PLANNING DEPARTMENT

Ohana Dwelling Unit Permit Application (ohd-06-000091)

Proposal: Construct An Attached Ohana Dwelling Unit

Tax Map Key: (3) 2-4-010:122

SITE PLAN

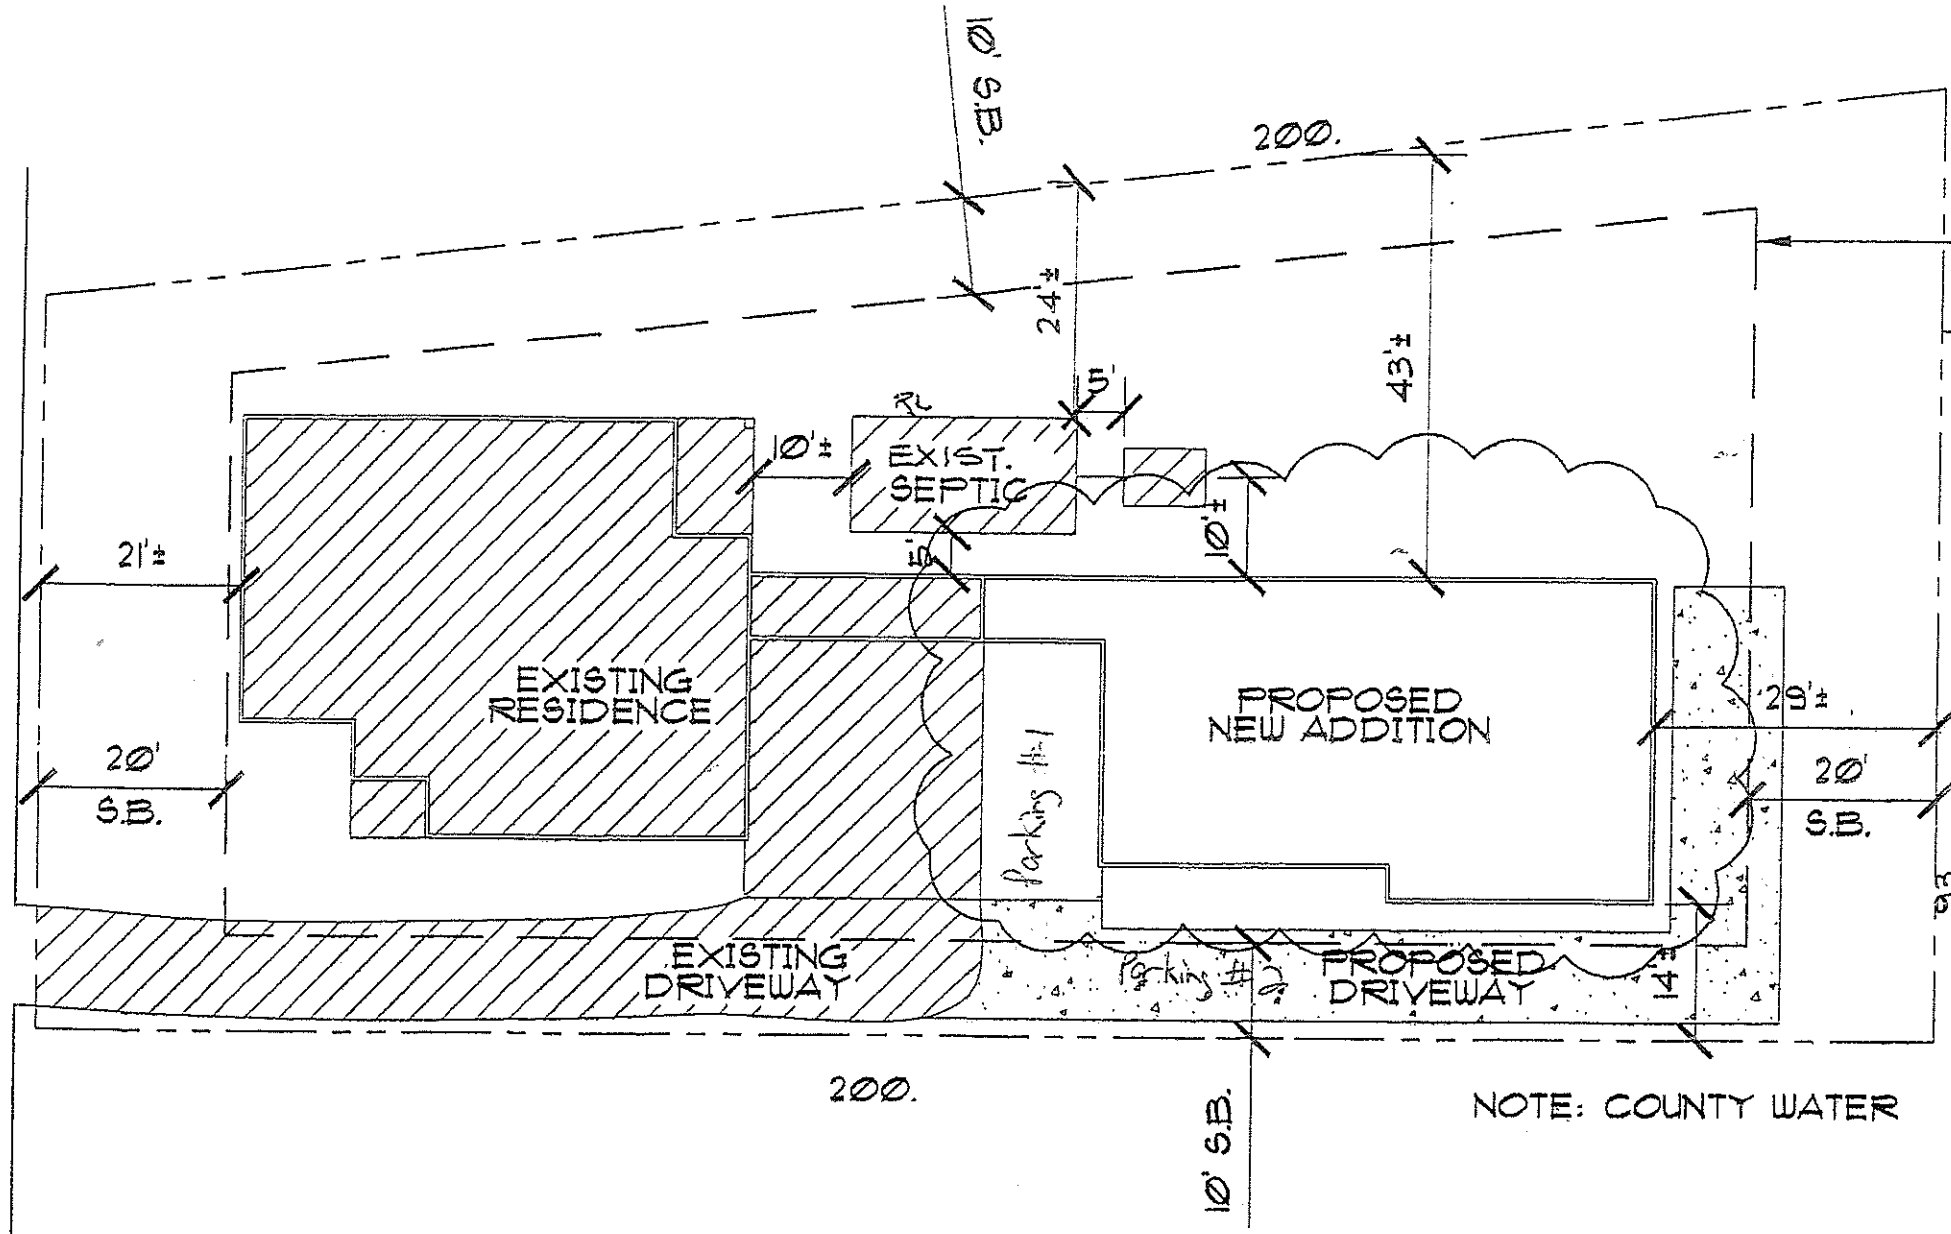
Please be informed that the subject parcel is currently served by a 1-inch service lateral, which is adequate for only one dwelling at an average daily use of 400 gallons. Inasmuch as this application is proposing an additional dwelling, the installation of a separate 5/8-inch meter will be required. Water can be made available from the Department’s existing 6-inch waterline within Mikihala Street, fronting the subject parcel.

1. Installation, by the Department of Water Supply, of a 1-inch service lateral to service a 5/8-inch meter, which shall be restricted to a maximum daily flow of 600 gallons.
2. Remittance of the following charges, which are subject to change, to our Customer Service Section:

“The septic system is designed for five (5) bedrooms. The total number of bedrooms cannot exceed five (5) bedrooms.
